ECR on surface technical galleries at Point 1 and Point 5

HL-LHC TCC, 17 January 2019

HL – LHC Engineering Change Request
MODIFICATION OF THE TECHNICAL GALLERIES AND BUILDING
INTERFACES AT HL POINT 1

HL – LHC Engineering Change Request MODIFICATION OF THE TECHNICAL GALLERIES AND BUILDING INTERFACES AT HL POINT 5

Point 1 before SMR process

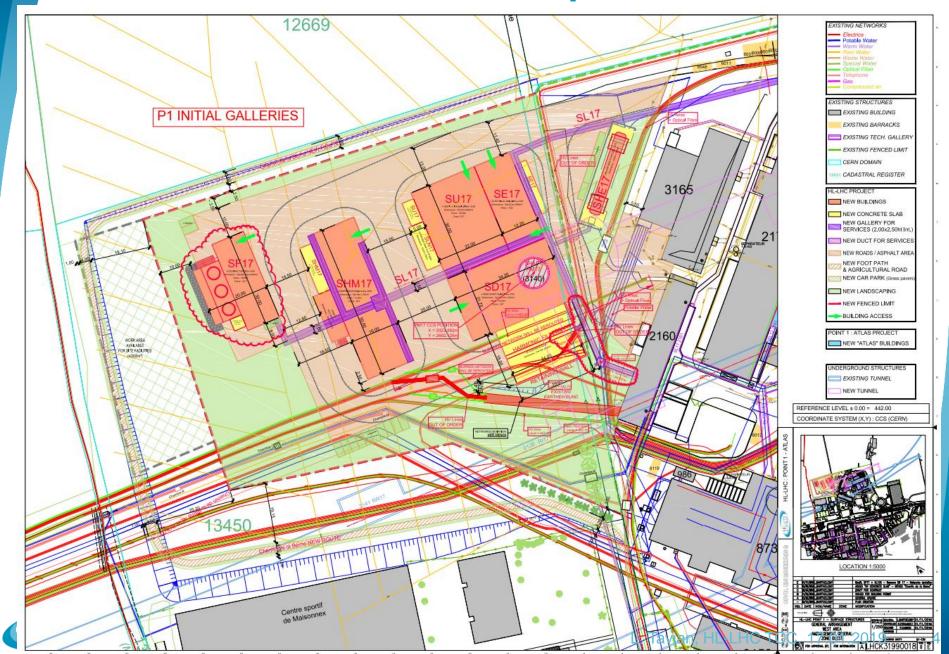
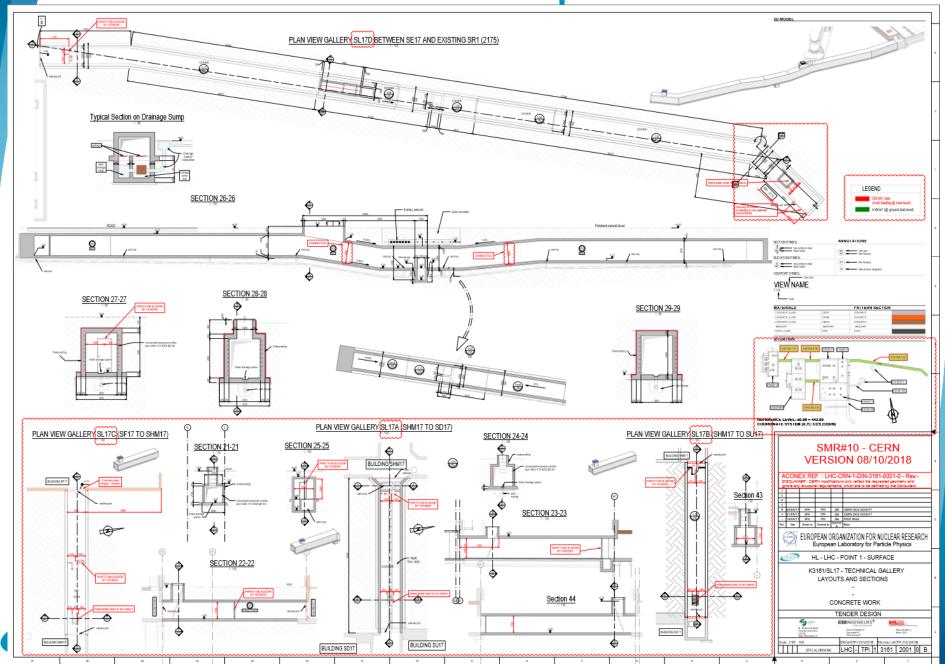
As consequence of the integration studies several changes have been identified and analyzed on the SMR id 10 EDMS 1864762 to guarantee a satisfactory installation of the services of WP17.2, WP17.3, WP9

- With respect to the CE tendering specifications, iterations on the integration of services and infrastructures has requested modifications in the design of the surface technical galleries and their interfaces with the buildings.
- SMRs (Space Modification Requests) have been issued to define new requests.
- This iteration process has impact on:
 - The civil engineering design (Consultant contracts)
 - The construction works (BoQ) (Main Contractor contracts)

Point 5 before SMR process

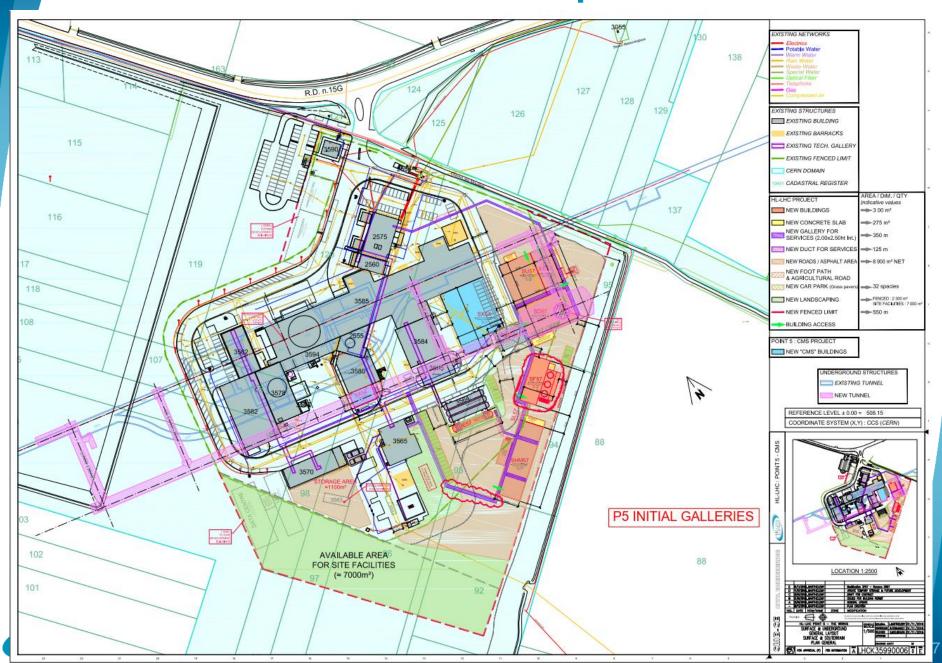
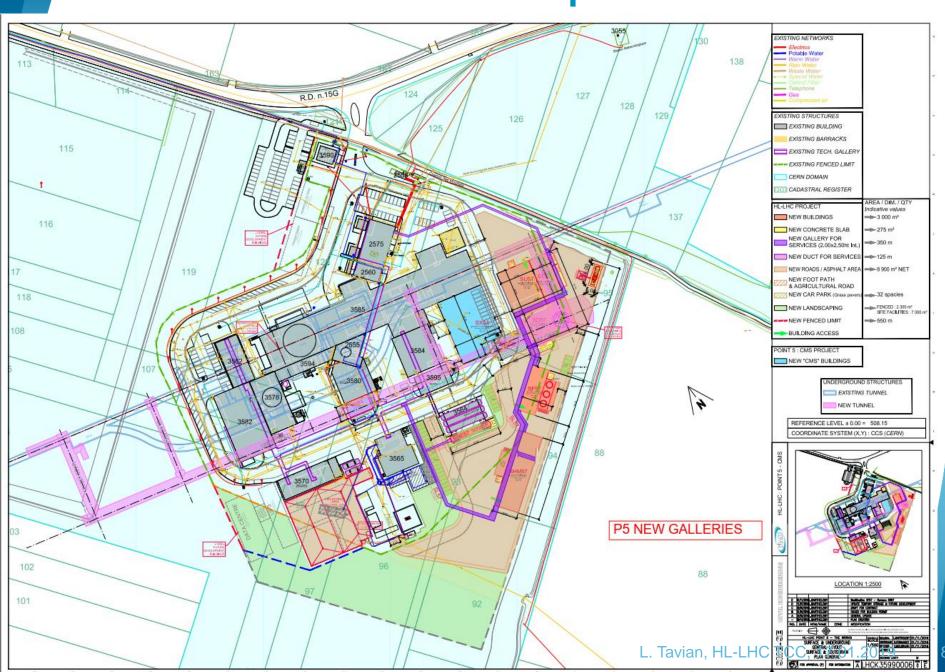
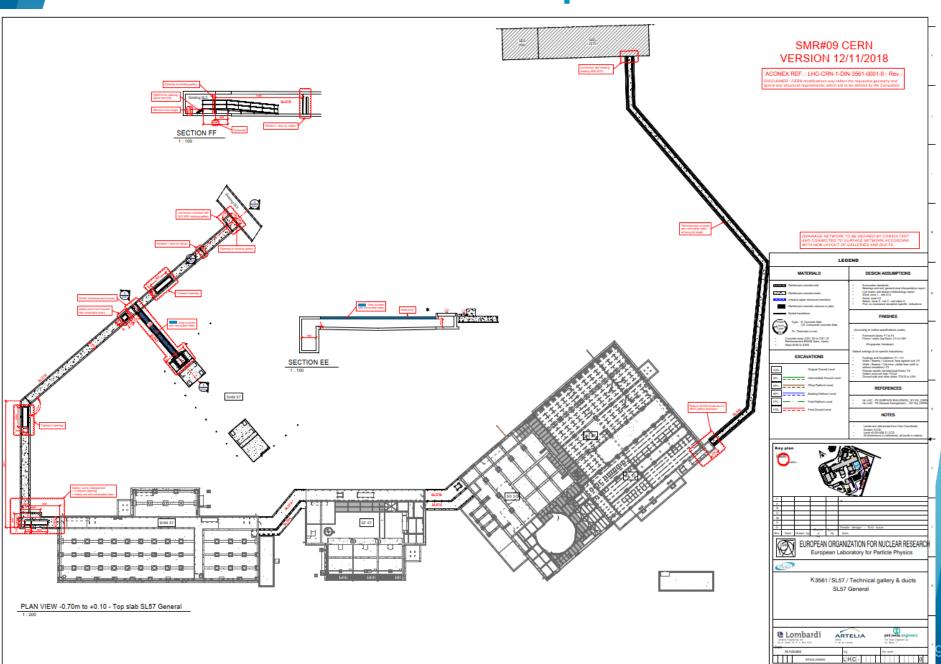
As consequence of the integration studies several changes have been identified and analyzed on the SMR id 9 EDMS 1864761 to guarantee a satisfactory installation of the services of WP17.2, WP17.3, WP9 Those changes were accepted by WP17 WPL and WP 15 WPL on 2018-12-12.
